RE: SSD-88004956 Lourdes Retirement Village – Seniors Housing 95-97 Stanhope Road, Killara - (SSDA)

Opening Statement

Figure 5 Bushfire Attack Level Map

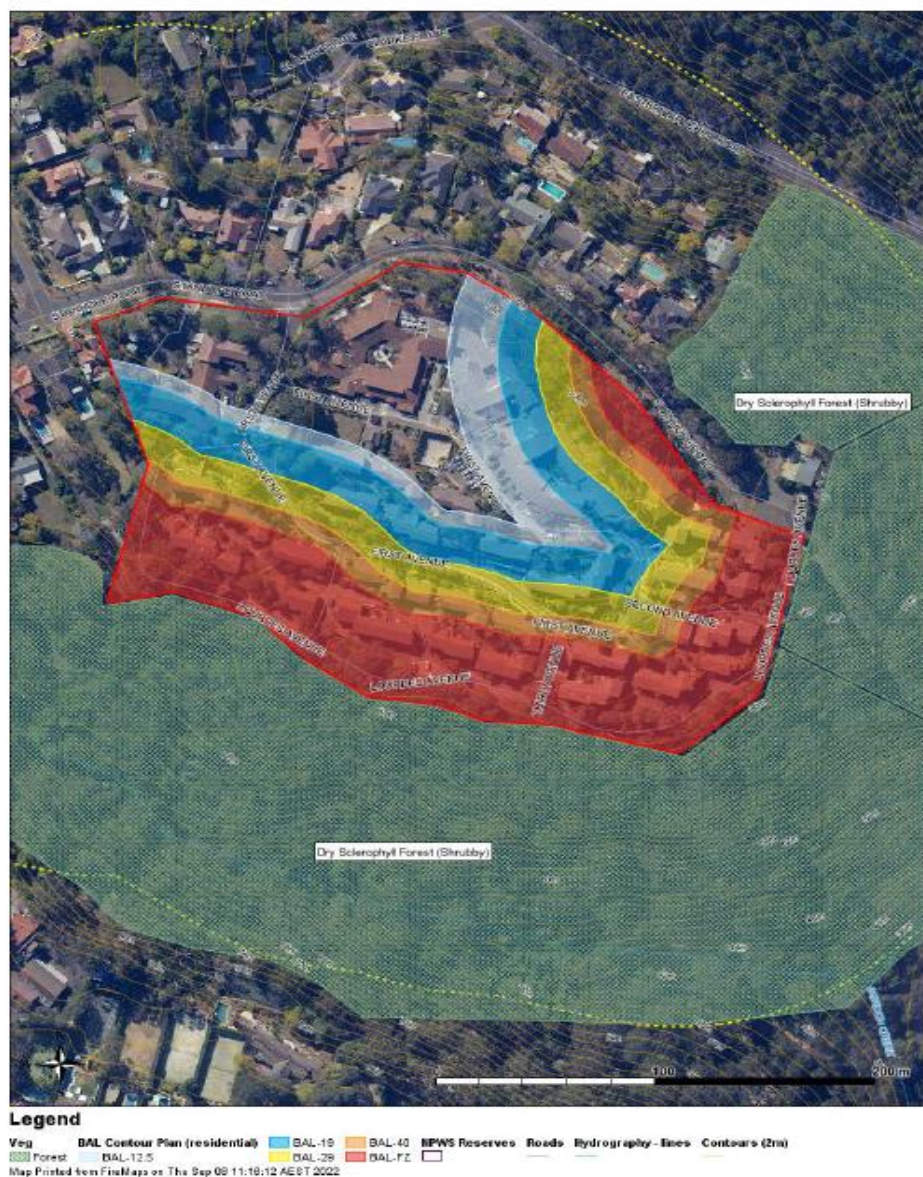
The map demonstrates that a minimum 100metre APZ is required for the Lourdes site. The SSD-88004956 proponent is proposing an APZ ranging in area from 36m-56m within the BAL Flame Zone

Figure 5 bushfire attack level map is taken from the Ku-ring-gai Council submission -October 2022 in response to Planning Proposal PP-2022-658. To rezone and increase height and FSR at 95-97 Stanhope Road, (Lourdes Retirement Village).

Figure 5 Bushfire overlay on the proposed development

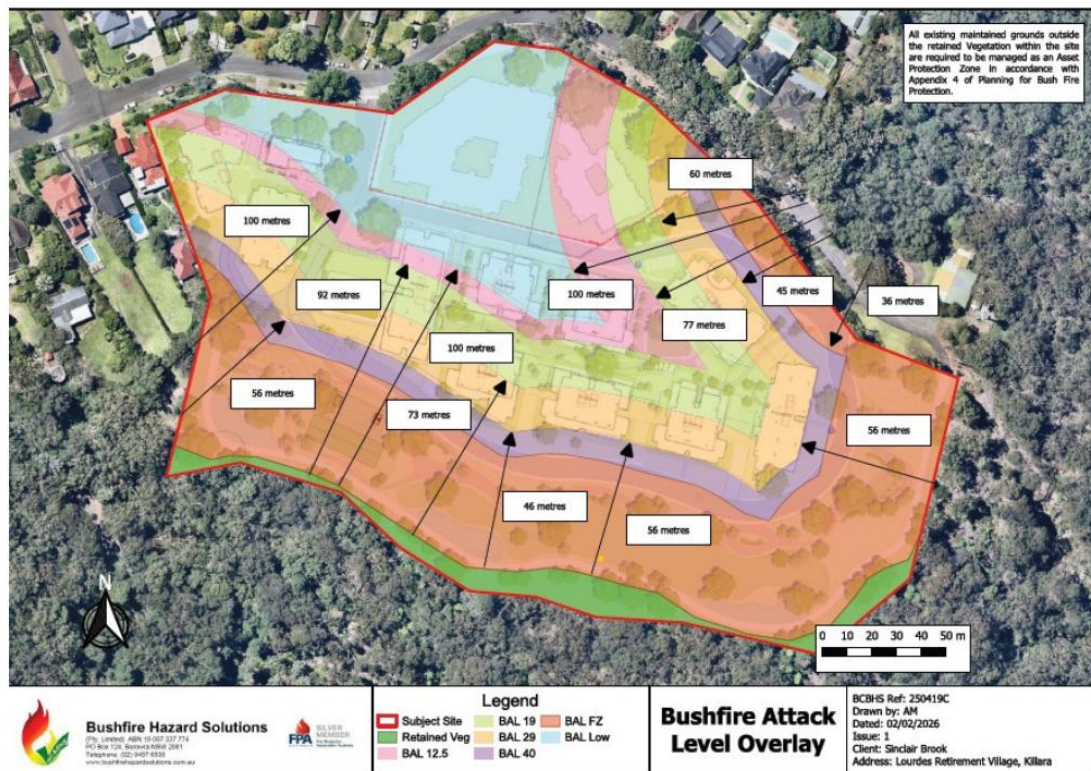
The application's reliance on a variable 36m to 56m Asset Protection Zone (APZ) to reduce hazard exposure down to a BAL-29 threshold constitutes an unacceptable risk and a regulatory non-compliance for a vulnerable, non-ambulatory demographic. While a BAL-29 rating successfully pushes the building footprints out of direct flame contact (BAL-FZ), it fundamentally fails the prescriptive mandate of the NSW Rural Fire Service (RFS) *Planning for Bush Fire Protection* (PBP) for Special Fire Protection Purpose (SFPP) seniors' housing.

Furthermore, the 2026 landscape design introduces a severe regulatory contradiction: it proposes structural tree canopy planting (*Tristaniopsis laurina*, *Elaeocarpus reticulatus*) inside a compressed buffer zone servicing BAL-29 envelopes. This strategy violates RFS Inner Protection Area (IPA) standards and directly clashes with [Ku-ring-gai Council's strict environmental policies](#).

1. Increase the minimum property setback to a uniform, un-vegetated 60m+ APZ across all boundaries interfacing with Category 1 Forest lines to successfully drop radiant heat to the mandated 10 kW/m² SFPP standard.
2. Redesign the landscape matrix to eliminate all canopy tree planting within the designated 36-metre bottleneck corridors, ensuring full compliance with prescriptive NSW RFS IPA standards.

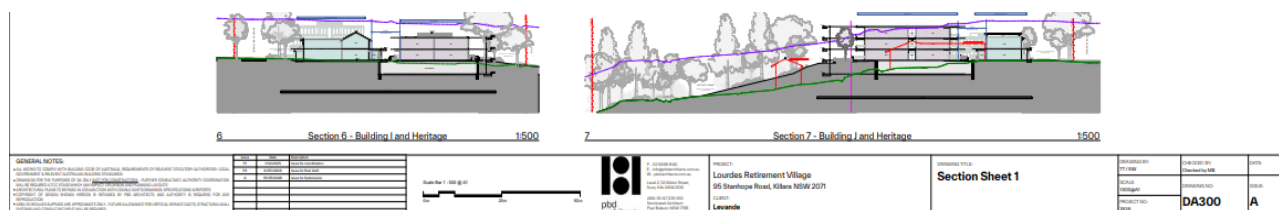
While the Urbis European Heritage Impact Statement (HIS) concludes that the SSD-8804956 master plan delivers a net positive heritage outcome, the report— identifies several distinct elements that could be considered to negatively impact, crowd, or devalue the overall heritage significance of Headfort House and surrounding Heritage Conservation Area - Crown Blocks - (C22) and heritage items.

We have concerns that there will **not** be a net positive outcome for Headfort House with the proposed changes both externally and internally and particularly with the excavation and concrete construction of 4.2-metre-deep car parking basement adjacent to the curtilage of Headfort House for Buildings I and J. The 4.2m excavation could not only impact the heritage house structurally but also impact the water table which could impact Headfort House foundations.
